**TRANSMITTAL OF ADDENDUM 3 TO THE CERTIFICATION DESIGN LETTER
FOR AREA 1, PHASE II CERTIFIED FOR REUSE AREAS, TRAP RANGE,
SECTOR 2C AND SECTOR 3**

**ADDENDUM TO THE
CERTIFICATION DESIGN LETTER
FOR AREA 1, PHASE II,
CERTIFIED FOR REUSE AREAS,
TRAP RANGE, SECTOR 2C, AND SECTOR 3**

**FERNALD CLOSURE PROJECT
FERNALD, OHIO**

**20710-RP-0014
REVISION 0
ADDENDUM 3**

FIGURE 1-2. CU A1P2-S3DP-02 LOCATION MAP

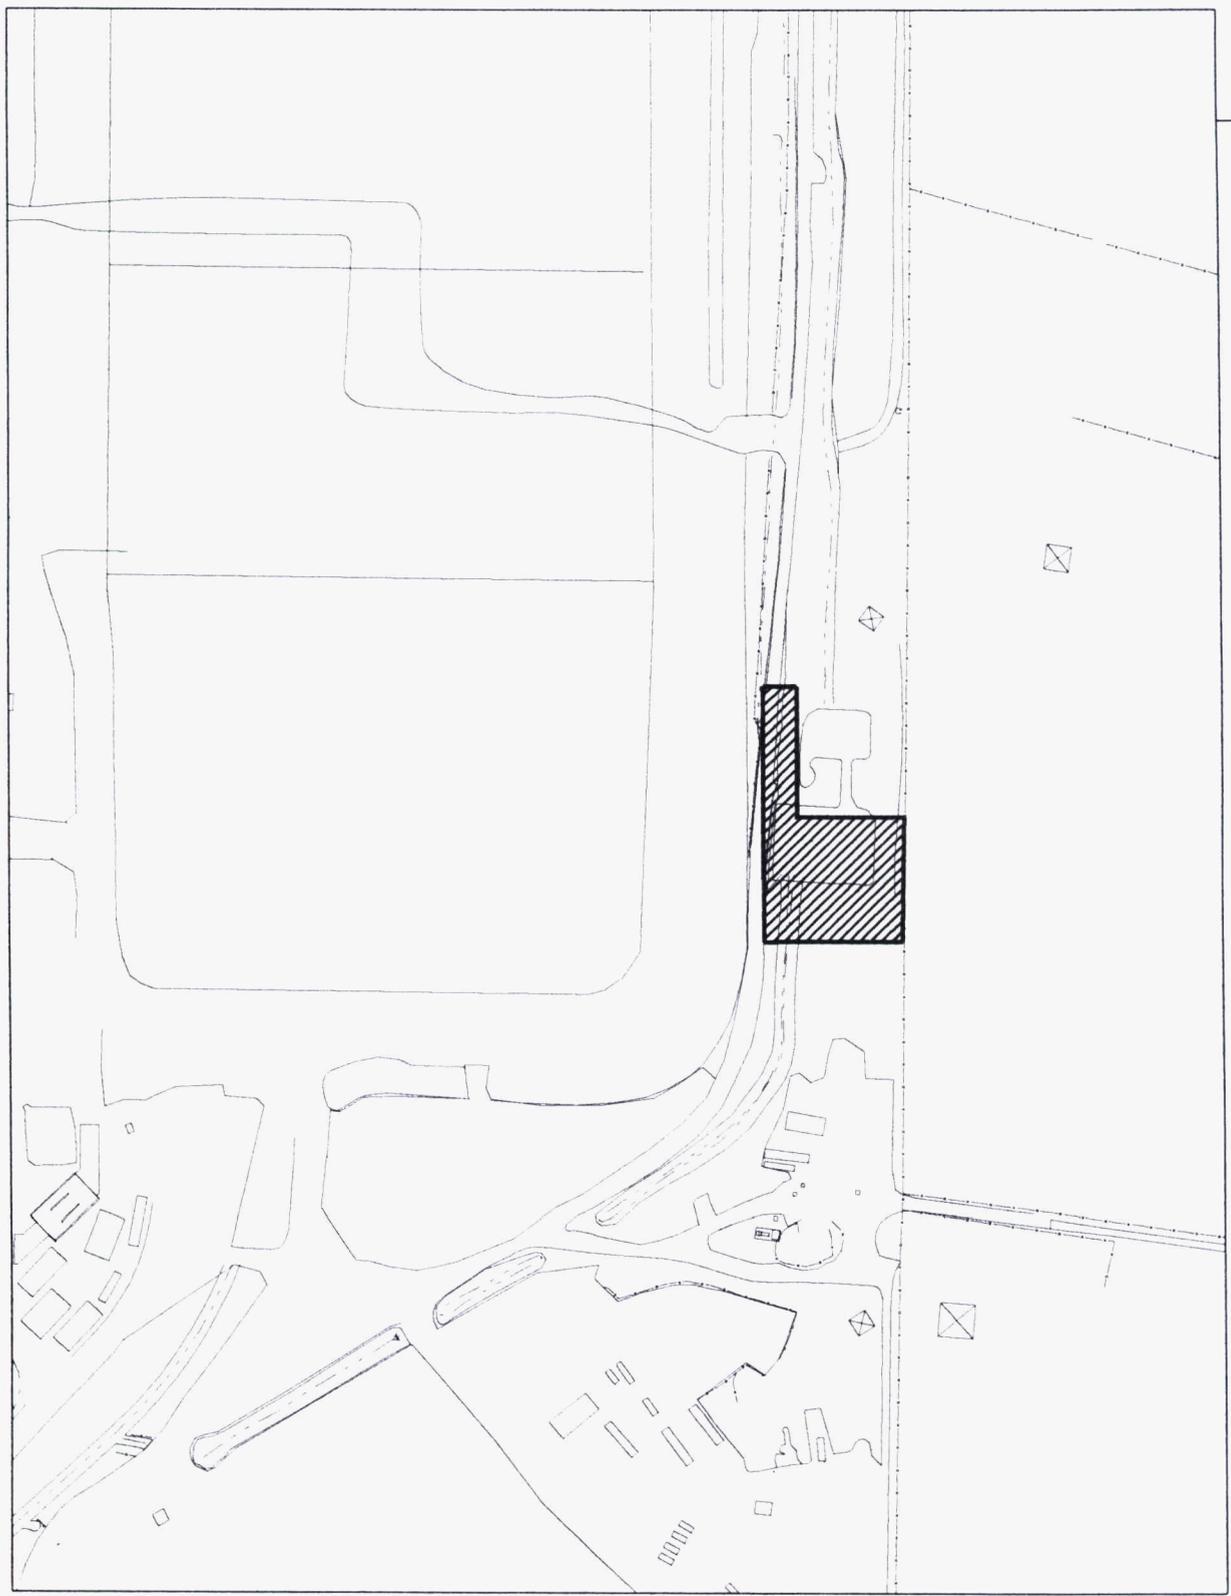
Also included in this addendum is the addition of two samples to previously certified CU A1P2-S3DP-02. Within this CU, a piece of clay pipe was encountered during the excavation/relocation of a drainage ditch east of Cell 8. Figure 1-2 shows the location of CU A1P2-S3DP-02.

FIGURE 4-2. SAMPLE LOCATIONS FOR CU A1P2-S3DP-02

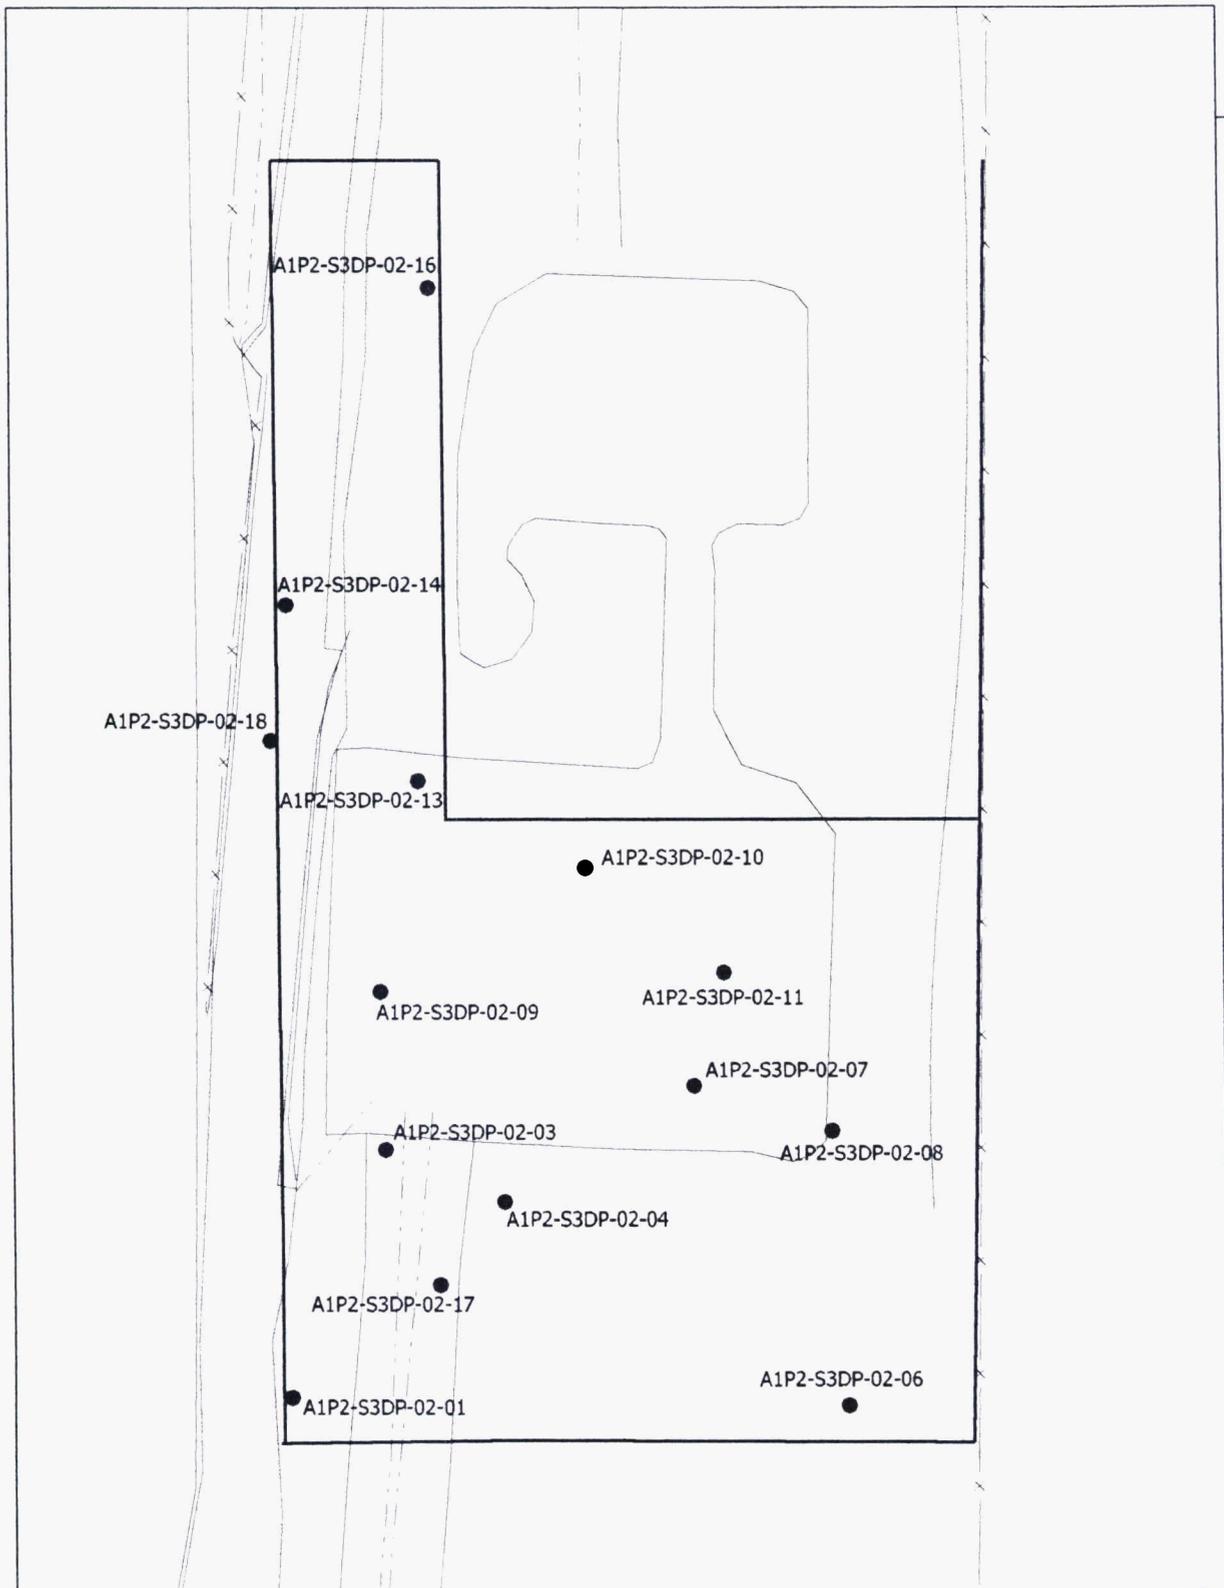
In CU A1P2-S3DP-02, two additional samples were collected under V/FCNs 20710-PSP-0009-27 and 28 (DOE 1999) due to the discovery of clay pipe in the area. The sample locations (A1P2-S3DP-02-17 and A1P2-S3DP-02-18, respectively) are shown on Figure 4-2, and both V/FCNs are provided in Appendix D.
